EN - Addendum instruction

The new MCA2R10 control unit (fig.1) replaces the MCA2 control unit (fig.2) and is compatible with the following motors: WG2024, WG3524, WG4024, WG5024, TOO3024, TOO4524 and XME2024 (including for very old models).

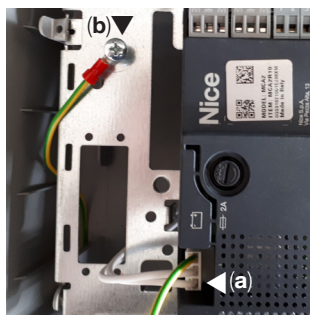
• Changes made to the MCA2R10 control unit terminals:

- **M1 output:** has been moved to the side of the **M2 output**
- **RADIO:** a radio receiver with capacity for 100 transmitters has been integrated and the programming key has been added
- **Transformer:** the transformer connection has been modified because the diode bridge is no longer present
- **MOTOR SELECTION:** 4 dip switches have been added for motor type selection
- **OVVIEW:** a connector for the IBT4N adapter has been added (connector for the Oview control unit programmer)
- P.P. **Terminal:** renamed "**Sbs**" = the function has not changed
- **S.C.A.:** renamed "**OGI**" = the function has not changed
- **OK Led:** under normal conditions, the LED light is green

3 A - Remove the 4 screws from the transformer support 	B - Remove the 2 wires that connect the bridge to the transformer 	C - Remove the wires and the diode bridge 	D - Close the transformer support box with the 4 screws 	E - Fix the control unit and connect the transformer cable (a) and the grounding cable (b) 
---	--	--	---	---

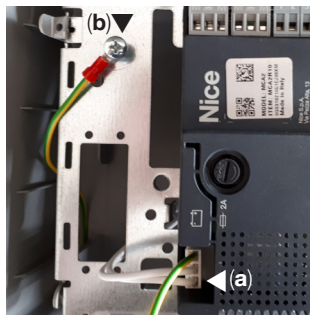
The new MCA2R10 control unit (fig.1) replaces the MCA2 control unit (fig.2) and is compatible with the following motors: WG2024, WG3524, WG4024, WG5024, TOO3024, TOO4524 and XME2024 (including for very old models).

• Changes made to the MCA2R10 control unit terminals:

- **M1 output:** has been moved to the side of the **M2 output**
- **RADIO:** a radio receiver with capacity for 100 transmitters has been integrated and the programming key has been added
- **Transformer:** the transformer connection has been modified because the diode bridge is no longer present
- **MOTOR SELECTION:** 4 dip switches have been added for motor type selection
- **OVVIEW:** a connector for the IBT4N adapter has been added (connector for the Oview control unit programmer)
- P.P. **Terminal:** renamed "**Sbs**" = the function has not changed
- **S.C.A.:** renamed "**OGI**" = the function has not changed
- **OK Led:** under normal conditions, the LED light is green

3 A - Remove the 4 screws from the transformer support 	B - Remove the 2 wires that connect the bridge to the transformer 	C - Remove the wires and the diode bridge 	D - Close the transformer support box with the 4 screws 	E - Fix the control unit and connect the transformer cable (a) and the grounding cable (b) 
--	---	---	--	--
